ADDENDUM

ADDENDUM NO. 3

RE: New Bedford Marine Commerce Terminal
Phase 3 Bulkhead Replacement (Site 4)
Massachusetts Clean Energy Technology Center
Contract No. MACEC-FY26-02

SHEET TITLE:
MARINE
INFRASTRUCTURE
PILE CAP
LAYOUT
PLAN

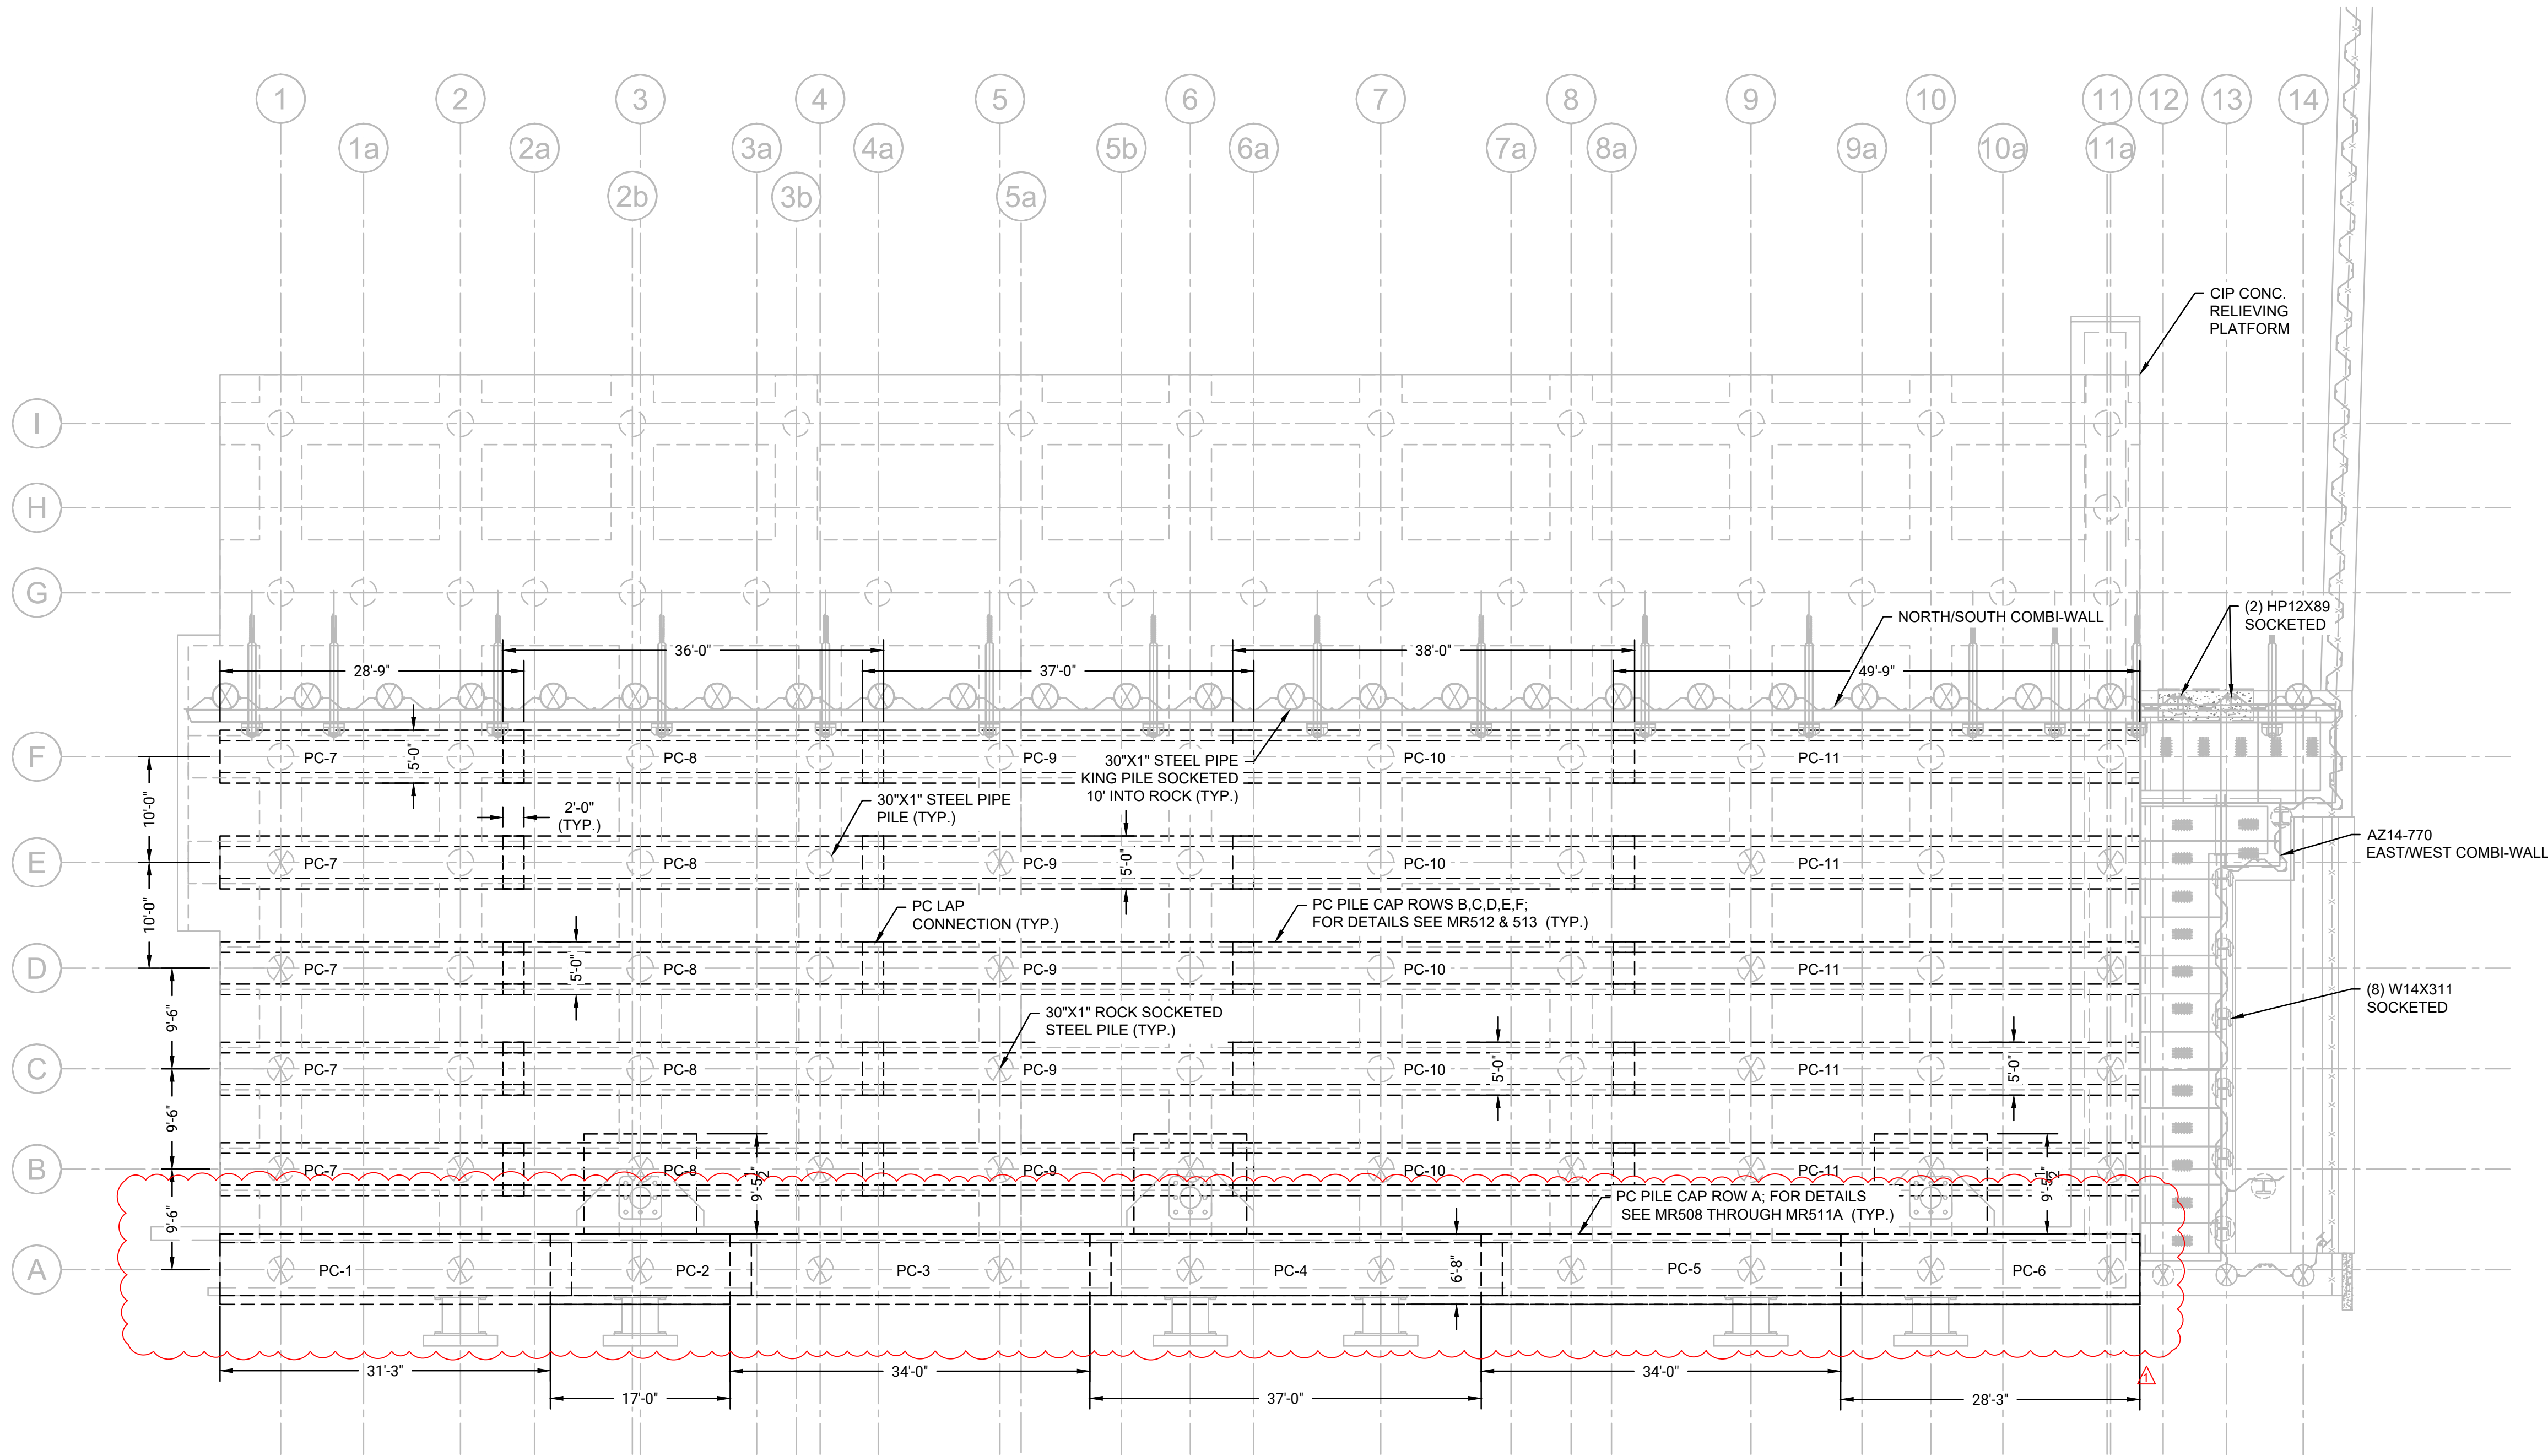
1. Drawings MR102 and MR508 through MR511 have been revised to reflect precast pile cap configuration addressing Question #2 (below). The revised Drawings are provided in **Attachment 1** to this Addendum No. 3.

1. Q: Will spiral weld pipe be acceptable?
A: YES, spiral weld pipe will be allowable steel pipe pile product.
2. Q: Are Pile Caps PC-1 to PC-8 connected to each other? If so, please provide a connections detail.
A: Please refer to the revised Drawings MR102 and MR508 through MR511, and the new Drawing MR511A. PC-1 through PC-6 have been resized and detailed to address precast pile cap connections.
3. Q: Please refer to the snapshot below from MR017. The red hatched area represents a gap between the proposed platform slab and existing Cofferdam cell which will be exposed to the open water below. Please provide a closure detail between the proposed platform slab and Cofferdam Cell to close this space.
